EAL SCHEME REVISIONS ENCLOSURE SUMMARY

**Dominion Energy Nuclear Connecticut, Inc. (DENC)
Virginia Electric and Power Company (Dominion Energy Virginia)**

**Millstone Power Station Units 1, 2 and 3 and ISFSI
North Anna Power Station Units 1 and 2 and ISFSI
Surry Power Station Units 1 and 2 and ISFSI**

Figure 1: Containment Integrity or Bypass Examples

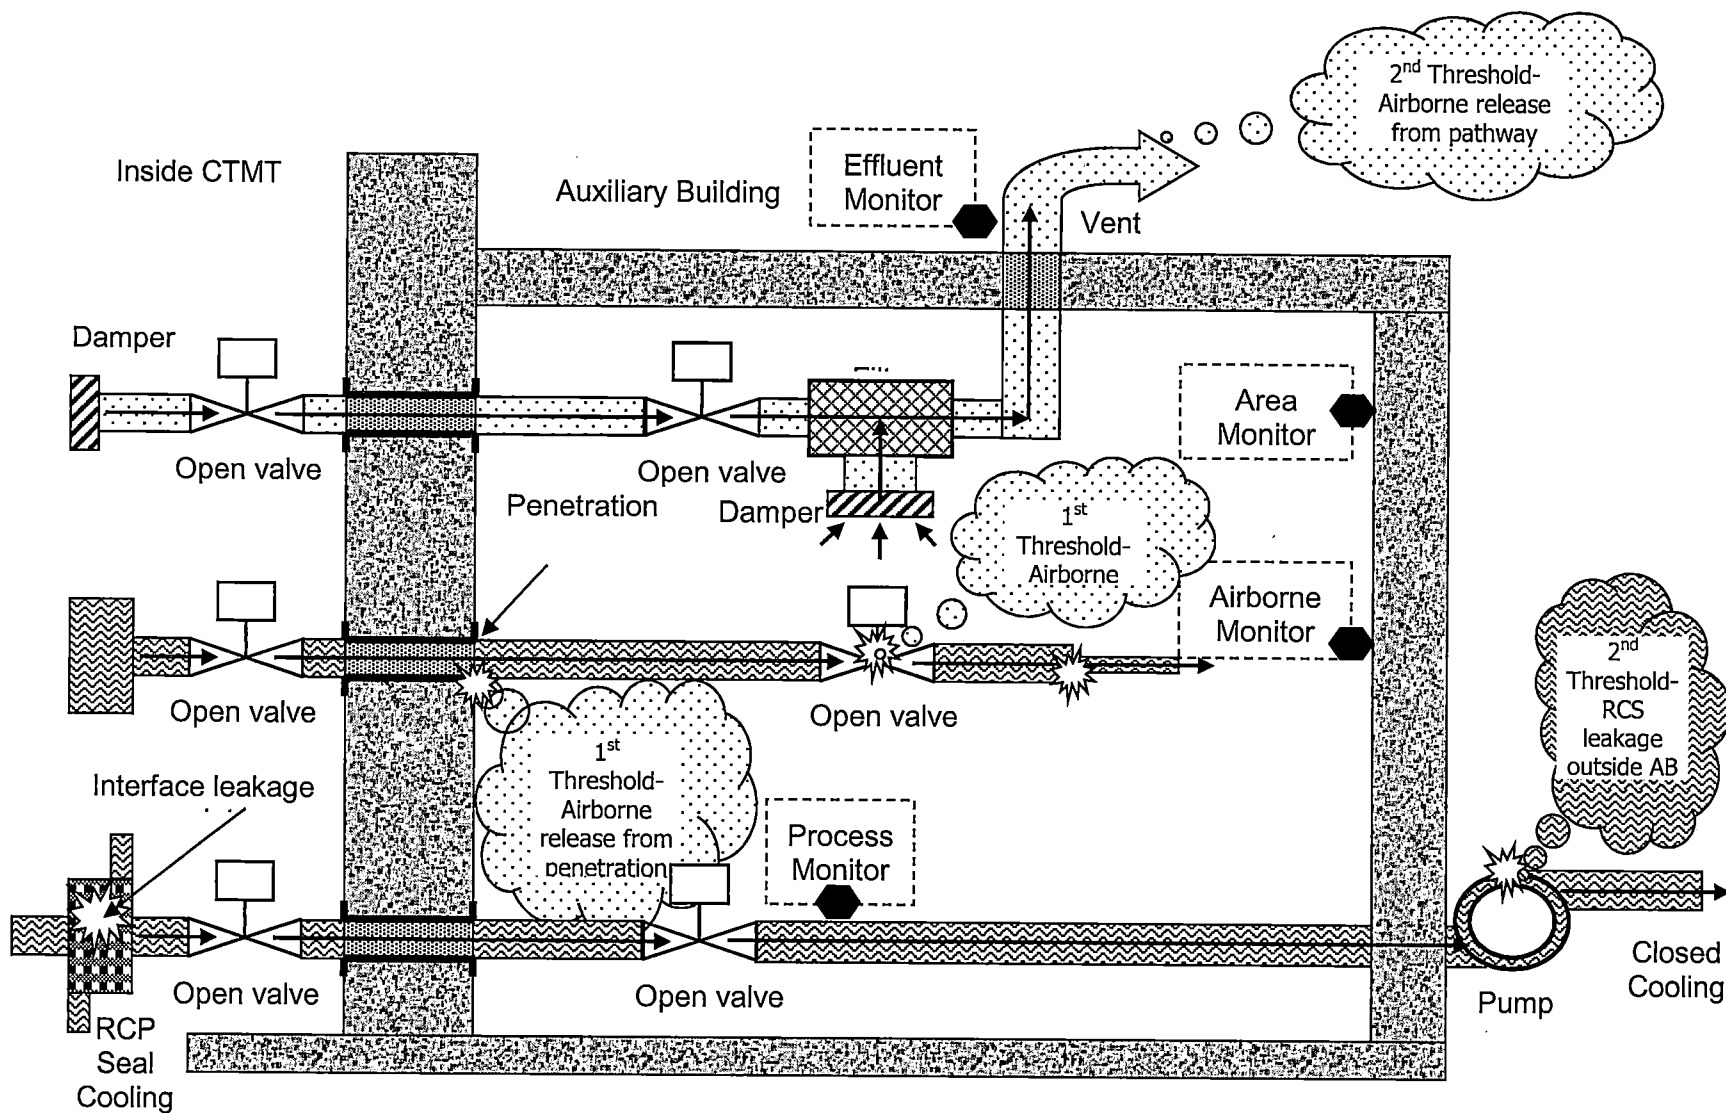
Refer to the middle piping run of Figure 9-F-41. Two simplified examples are provided. One is leakage from a penetration and the other is leakage from an in-service system valve. Depending upon radiation monitor locations and sensitivities, the leakage could be detected by any of the four monitors depicted in the figure.

Refer to the top piping run of Figure 9-F-41. In this simplified example, the inboard and outboard isolation valves remained open after a containment isolation was required (i.e., containment isolation was not successful). There is now an UNISOLABLE pathway from the containment to the environment.

Refer to the bottom piping run of Figure 9-F-41. In this simplified example, leakage in an RCP seal cooler is allowing radioactive material to enter the Auxiliary Building. The radioactivity would be detected by the Process Monitor. If there is no leakage from the closed water cooling system to the Auxiliary Building, then no threshold has been met. If the pump developed a leak that allowed steam/water to enter the Auxiliary Building, then the second threshold-4.B would be met. Depending upon radiation monitor locations and sensitivities, this leakage could be detected by any of the four monitors depicted in the figure and cause the first threshold 4.A.1 to be met as well.

Refer to the middle piping run of Figure 9-F-41. In this simplified example, a leak has occurred at a reducer on a pipe carrying reactor coolant in the Auxiliary Building. Depending upon radiation monitor locations and sensitivities, the leakage could be detected by any of the four monitors depicted in the figure and cause loss threshold CNB4-D.2 to be met as well.
